Proposal supplementing document GRSG/2023/16 for Supplement 1 to the 05 Series of Amendments to UN Regulation No. 46 (Devices for indirect vision)

Figure 1 (a): Traditional outside mirror

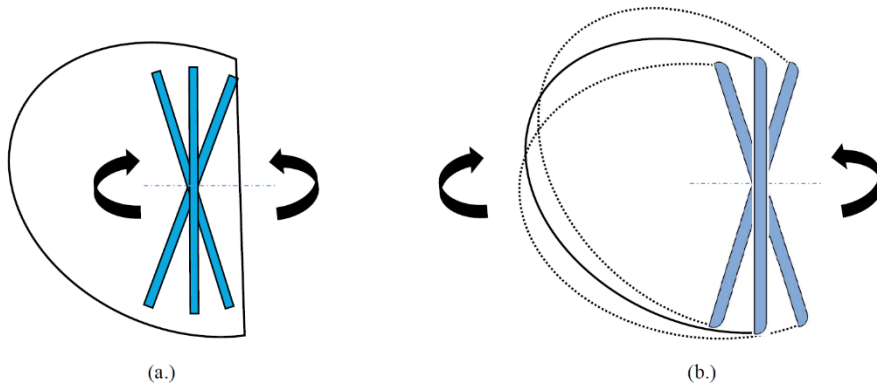
3. For Class II to VII mirrors, it is only possible to have a reflecting surface projecting beyond the housing in single adjustment positions. In this case, the reflecting surface must return into the protective housing if a force of 50 N is applied. This requirement cannot be met by mirrors where the reflecting surface is assembled onto the housing (frameless).

4. A frameless design of the mirror could reduce the width and height of the mirror significantly (up to 30 per cent). This would then have two major benefits: a reduction of collision probability with bicyclists/pedestrians and a reduction of the aerodynamic resistance (c_w).

~~In cases where~~ When the edge of the reflecting surface is enclosed in a protective housing (holder, etc.), the radius of curvature "c" on its perimeter shall be not less than 2.5 mm at all points and in all directions.

~~In cases where~~ When the edge of the reflecting surface projects beyond the protective housing independent from any adjustment position, the radius of curvature "c" on its perimeter shall be not less than 2.5 mm at all points and in all directions, and shall apply to the edge of the projecting part.

~~In cases where~~ When If the reflecting surface projects beyond the protective housing **in any adjustment position**, the radius of curvature "c" on the edge of the projecting part shall be not less than 2.5 mm and the reflecting surface shall return into the protective housing under a force of 50 N applied to the point of greatest projection, relative to the protective housing, in a horizontal direction, approximately parallel to the longitudinal median plane of the vehicle.
